No. 410

Subject: THE TEETH OF THE LOADING GEAR MAY BECOME BROKEN. THIS MAY HAPPEN IN MG-50 SERIES MECHANICAL DECKS.

Date: October 22, 1996

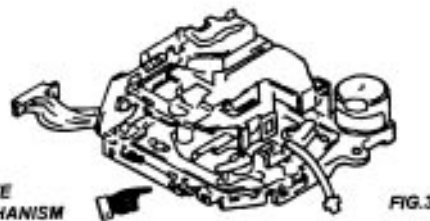
mechanism decks produced from Jan 1, 1995 to June 30, 1995 are applicable. The production date can be identified as shown in the illustration below

EXAMPLE: 45707_/_/_/_/C indicates mechanism was made on JULY 7, 1995. These numbers are printed on the mechanism. The applicable products will range from 450101_/_/_/_/C to 450630_/_/_/_/C
